TOWN OF RAYMOND

Planning Board Agenda

Application # 2022-001: A SITE PLAN application is being submitted by John Lorden of Tighe & Bond, Inc. on behalf of Pinard Waste. They are proposing to construct a 30' x 40' metal building, a 1,260-sf office addition, and 10,575 sf proposed addition/overhang for the recycling processing program. Also, to be included with the project, is a small parking area, existing gravel/paved areas to be repaved, site lighting, a truck scale, proposed electrical, and a proposed gravel area for storage. To offset newly paved areas, stormwater treatment practices in the form of infiltration ponds and gravel wetlands are proposed. Property is located at 3 Otter Court and Raymond Tax Map 28-4 / Lot 2.

Subject: Review of Application 2022-001 Site Plan Application – 3 Otter Court Raymond, NH 03077 (Tax Map 28-4 Lot 2)

C-101

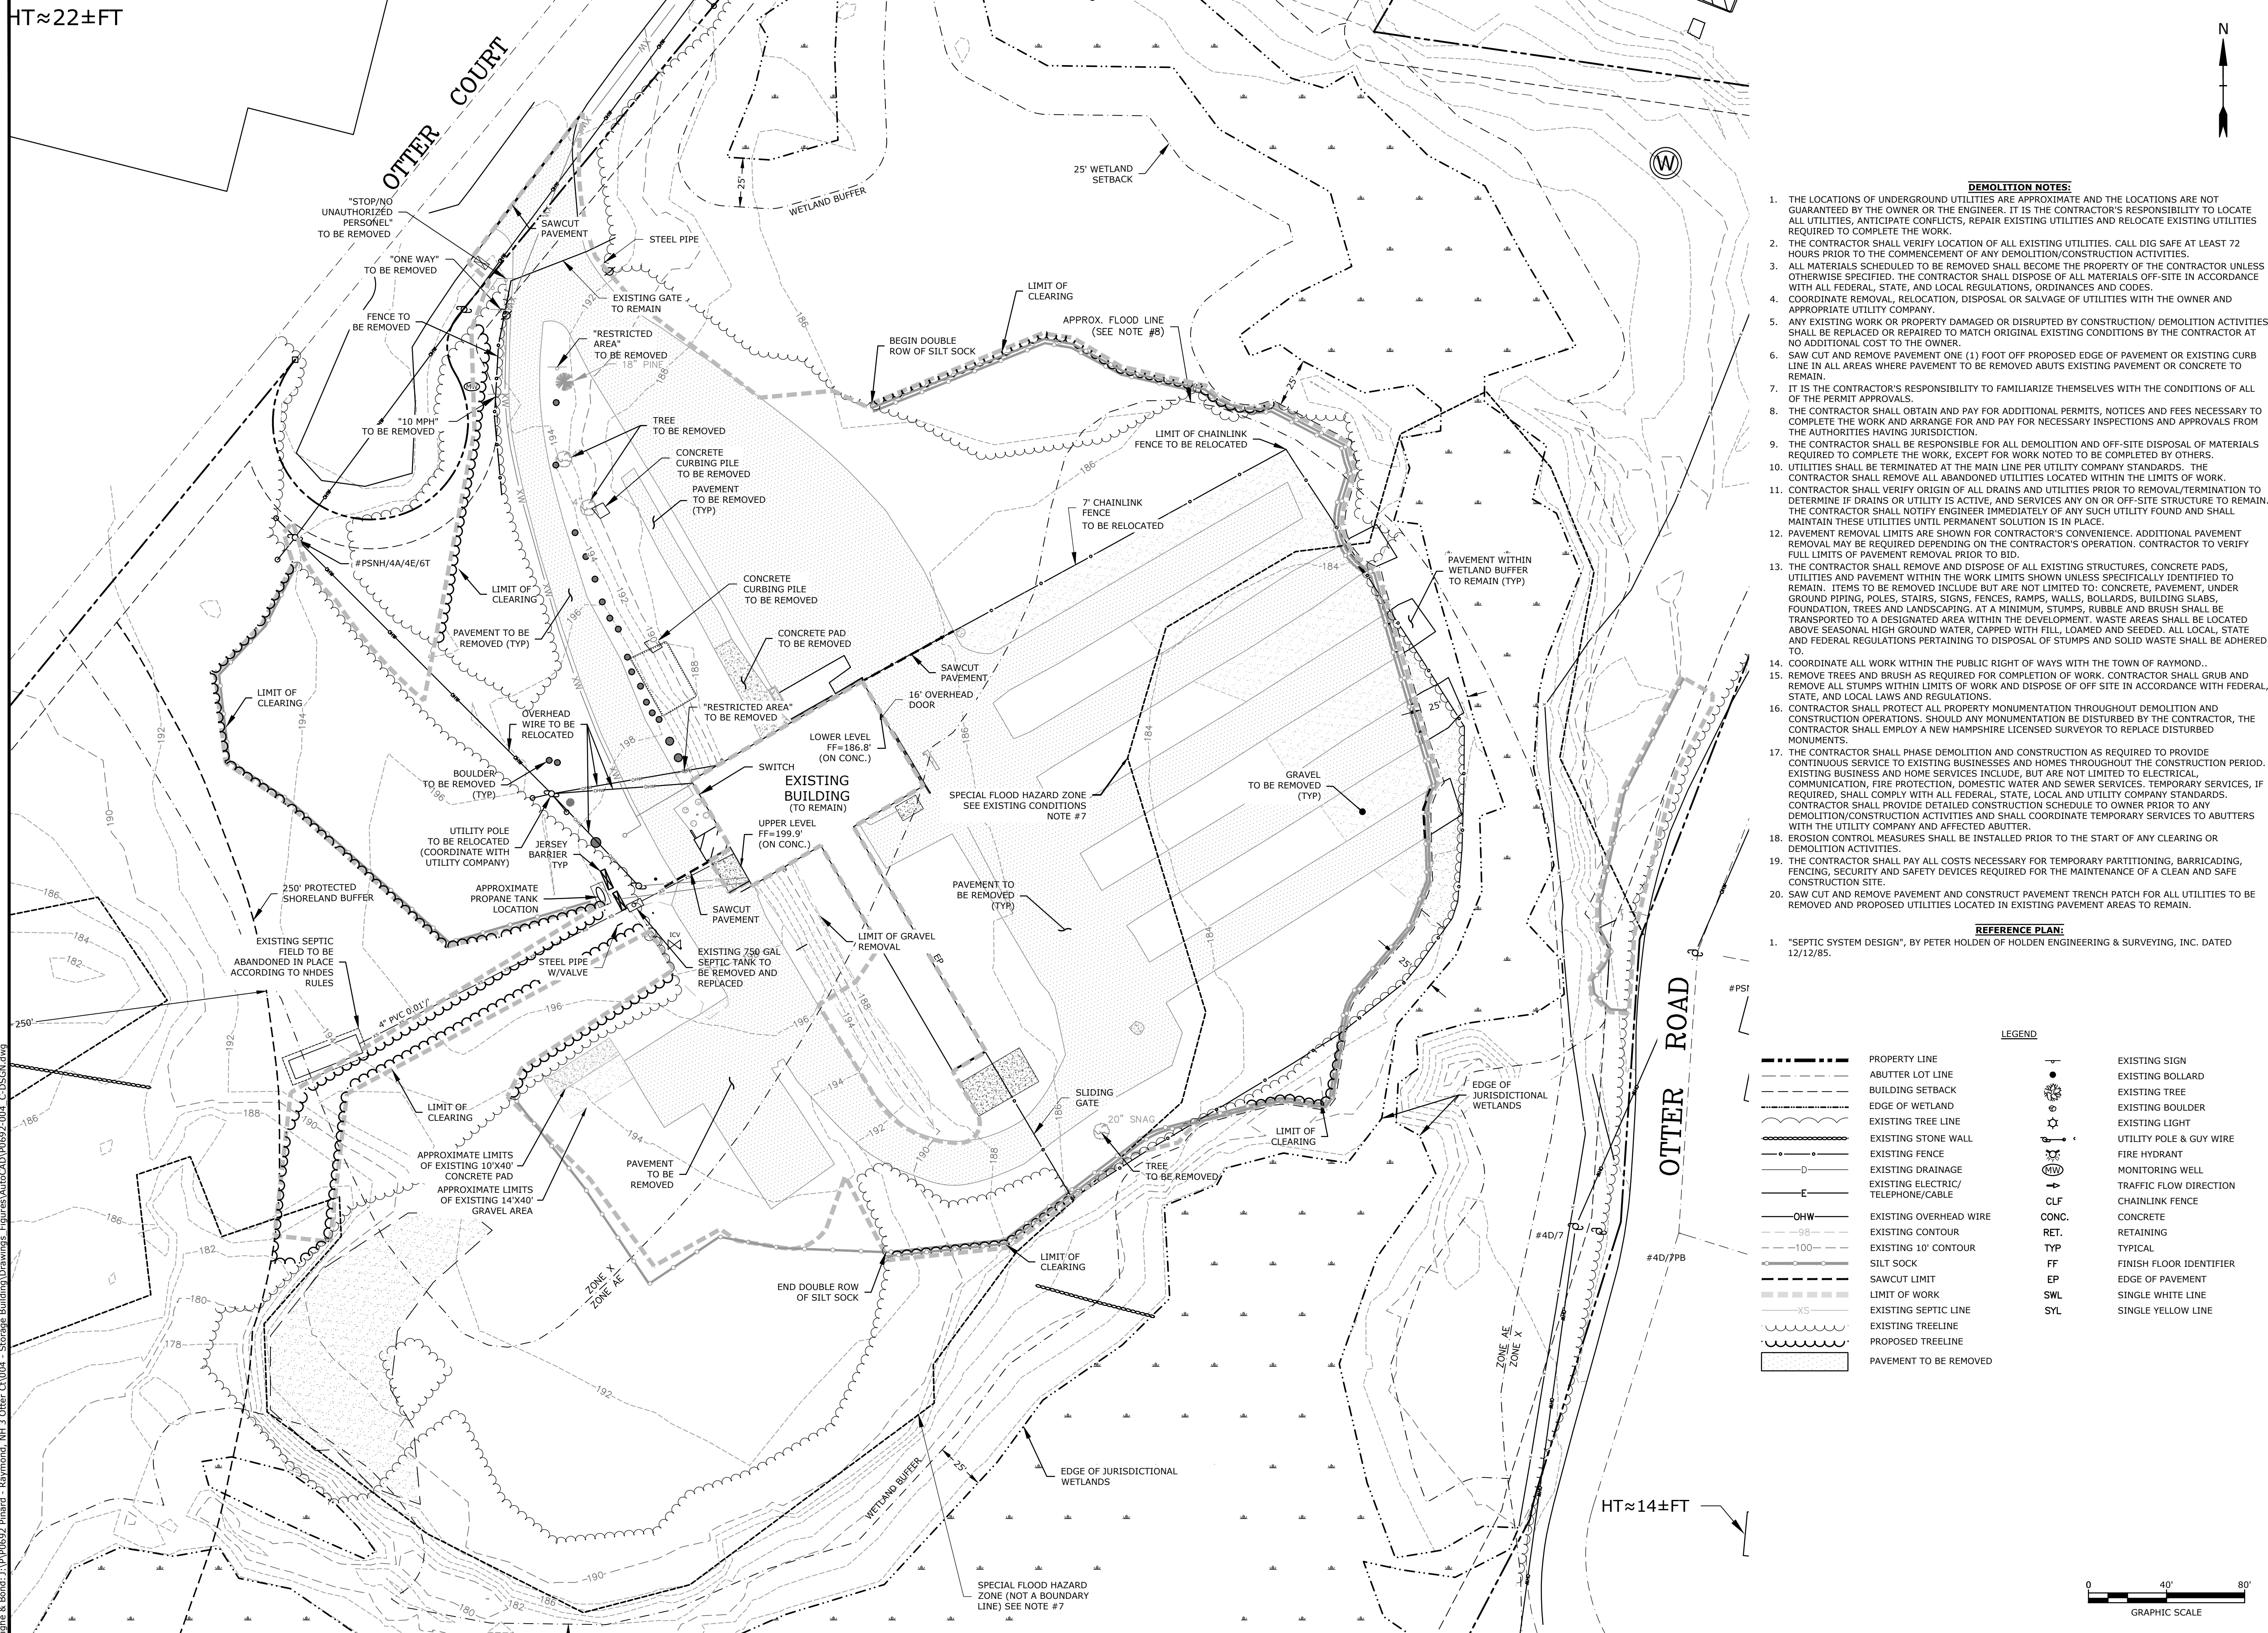
- 4. Demolition Plan, Sheet C-101.**
 - a. We recommend that Note 13 is revised to indicate all of the stump disposal requirements stated in Site Plan Regulations 6.13.03.

- a. We recommend that Note 13 is revised to indicate all of the stump disposal requirements stated in Site Plan Regulations 6.13.03.

Response: Note 13 has been revised to include provisions for stumps, rubble and brush.

C-105

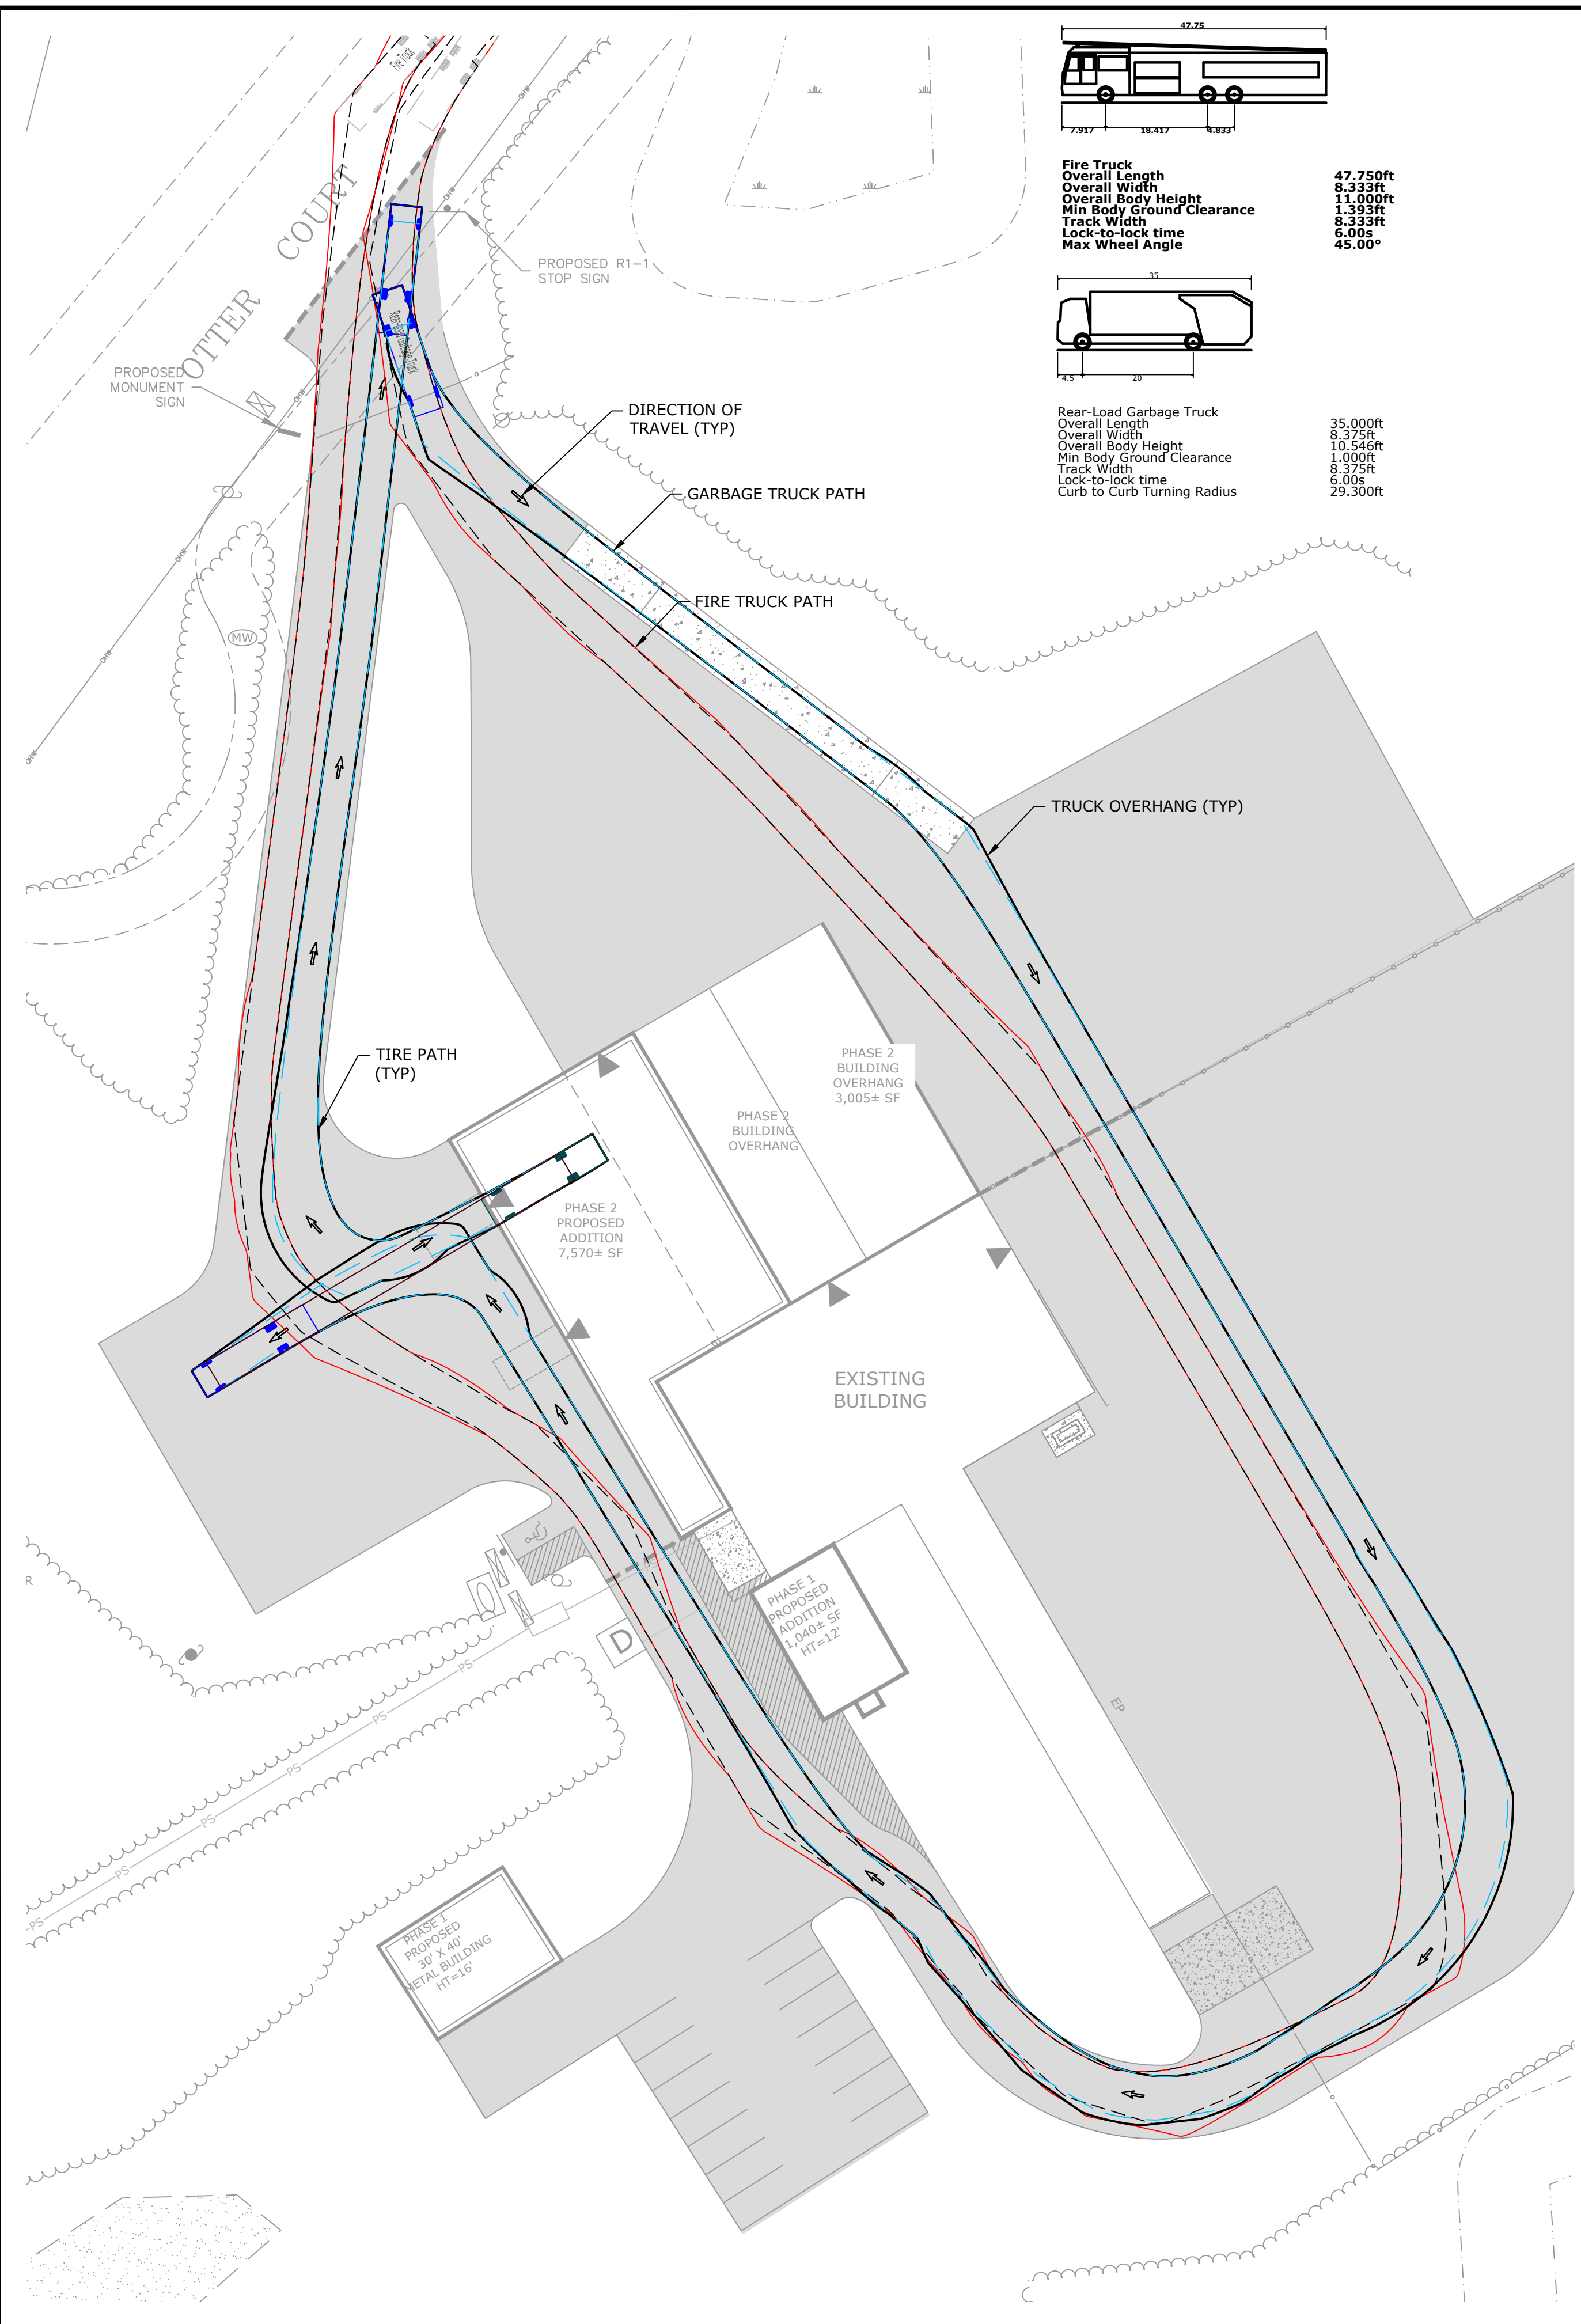
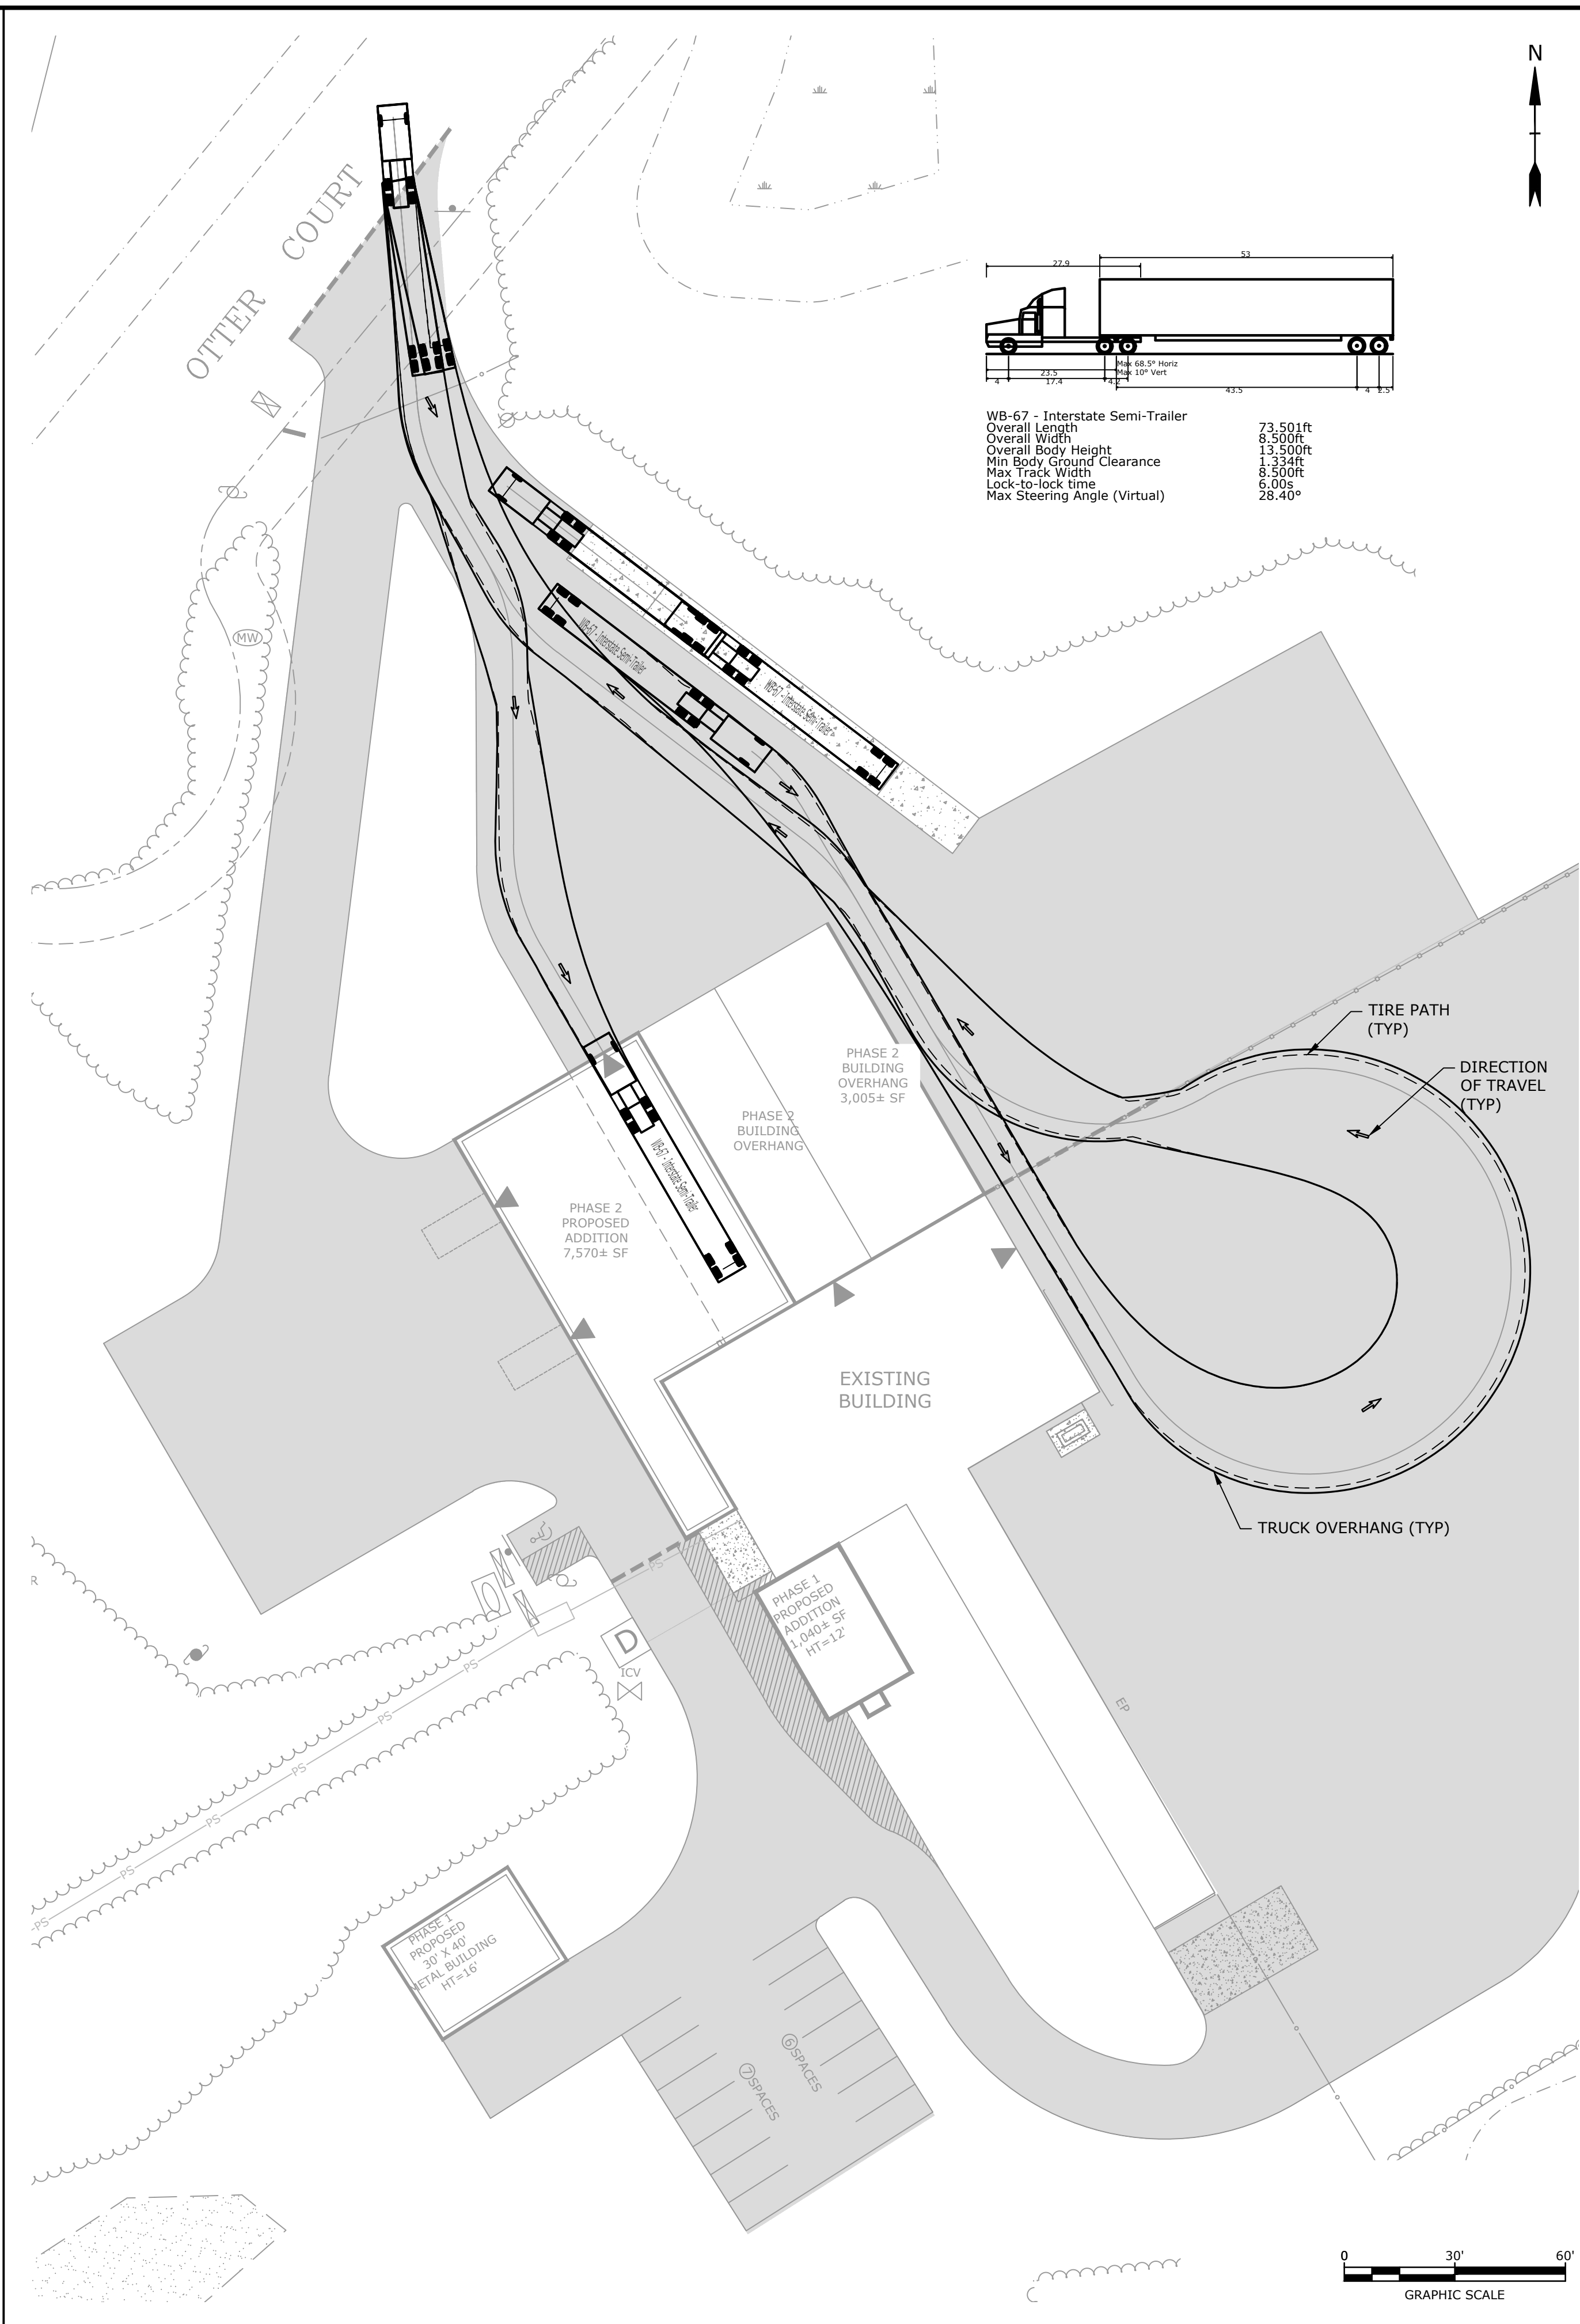
8. Truck Turning Plan, Sheet C-105

- a. We recommend that the Applicant revise the plan to provide fire truck turning movements.

- a. *We recommend that the Applicant revise the plan to provide fire truck turning movements.*
